Ruth Fletcher  
Horsham District Cycling Forum  
30 Ashleigh Rd  
Horsham RH12 2LF  
19<sup>th</sup> January 2015

**A264 junctions need urgent rethink for people walking and cycling**

Figure 5.8: Rusper Road Roundabout Potential Capacity Improvements

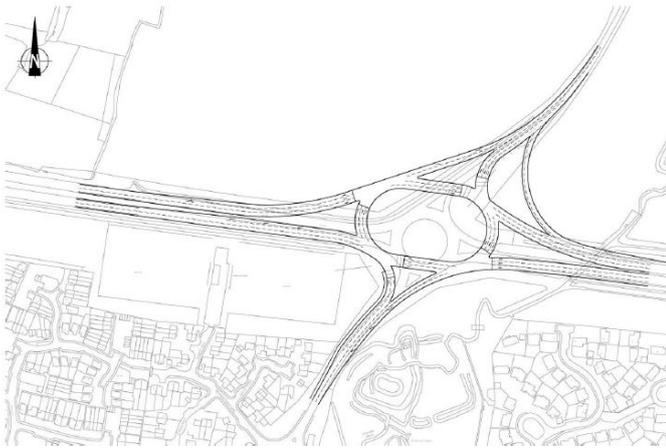
Even before the planned extra housing, this road carries 45,000 vehicles a day – that’s roughly 1 per second. Yet at the largest of these junctions on Rusper Road, children walking to school will have to cross up to 13 lanes of traffic in no less than 5 separate stages.

*Liberty wants people to cross these massive junctions on foot, in front of the traffic. Entering the site from Rusper Rd, means crossing up to 13 lanes of traffic in 5 separate stages:*

*Providing underpasses would minimise the need to climb, shorten crossing distance, take less land and be less visually intrusive. Nowadays, good design includes gentle slopes, a clear view through and wide entrances for social safety:*
